HONOLULU AUTHORITY for RAPID TRANSPORTATION

## **Revision to Trench Restoration Detail for the KHG Contract September 29, 2016**

**SUBJECT:** KHG Variation from Trench Restoration Detail  
Contract No. CT-HRT-11H0195

**Modified asphalt pavement restoration over trench excavations**

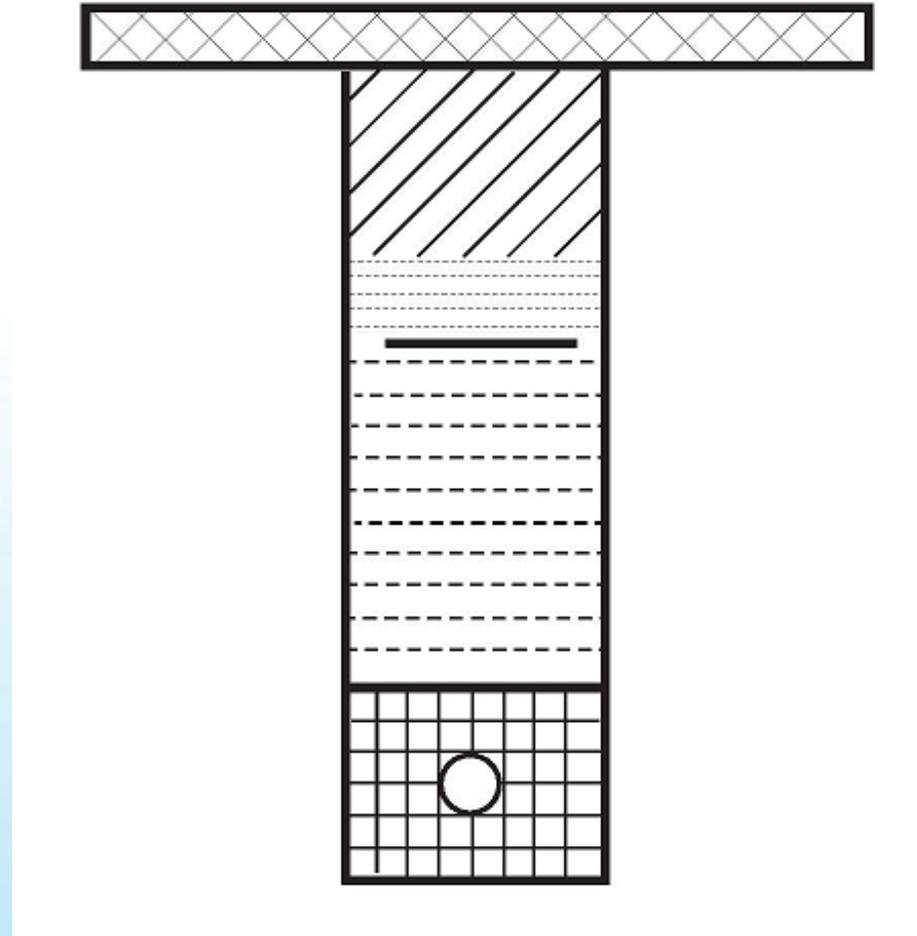
Issue: The contract specified a standard “T-Top” utility trench restoration detail. HDOT granted the request to remove the “T-Top” portion of the utility restoration trench during utility relocation work.

- “...the required “T-Top” portion of the trench restoration detail can be eliminated. Due to future proposed cold planing and resurfacing, any settlement of trench and adjacent areas should become evident by the time the final re-surfacing work occurs.”
- Should any settlement of the restored trench or other degradation occur – the Contractor would be required to repair said section prior to any cold planing and resurfacing work of the roadway.
